Access Compliance Report

Public Rights-of-Way

Intersection ID: 42359	Main Street: HERON_GLEN_DR	Cross Street: WRENS_NEST_LN	Location:	W
ADA ID: 1DCEF009FDF6	Ramp Type: PerpDiag	Initial Pass/Fail: Pass	Overall Compliance: No	Severity Score: 10

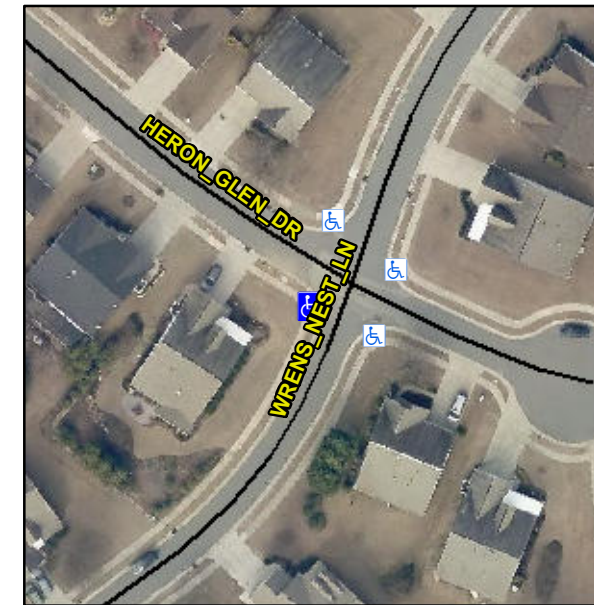
R304.2.2-Perp, R304.3.2-Para, R305, R304.5.3

Remove & Replace Curb Ramp With Two New Directional Ramps or Equivalent. Remove & Replace Gutter.
